Ref: C3104_P1
05 November 2024

Re: LLFA COMMENTS ON PLANNING APPLICATION REF; DM_23_3133- LAND AT GRID REFERENCE 526665 125250, BRIGHTON ROAD, WARNINGLID (ALSO KNOWS AS LAND ADJ HIGHFIELDS)

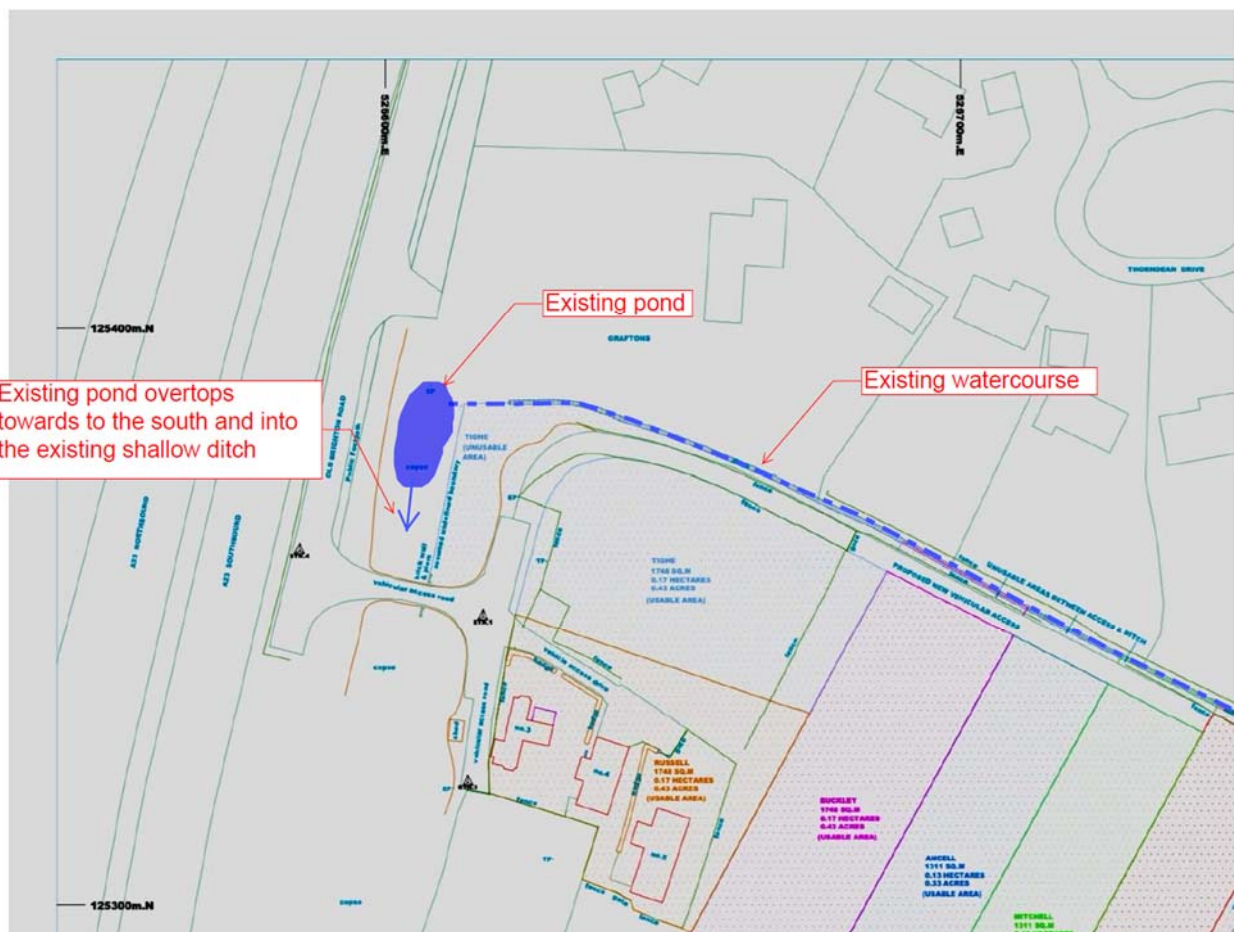
- *In site infiltration testing, to confirm the surface water infiltration rate*
- *Evidence that the existing ditch exist, has a wider connection to the surrounding area and it's inverts support the proposed drainage system.*
- *Evidence that the Environment Agency's General Building Rules have been considered with regards to the foul package treatment plant.*
 - o *We would advise that new rules have recently been added to the General Binding Rules, one of these rules prohibits new outfalls within 50m of an existing exempt small sewage discharge.*
 - o *If the drainage design would not meet with the Binding Rules, then an Environmental Permit will be required prior to the system being put into use. This is a separate process to planning but we would advise this is considered as part of the detailed design.*

A site infiltration test was conducted in accordance with the BRE 365 method, and results indicate slightly higher infiltration rates compared to the adjacent site, ranging from 2.28×10^{-5} m/s to 1.69×10^{-5} m/s. For design purposes, we have applied the worst-case infiltration rate of 1.69×10^{-5} m/s to the proposed soakaway and shallow permeable paving layout. Please refer to the attached updated drainage plan, calculations, and report for detailed information.
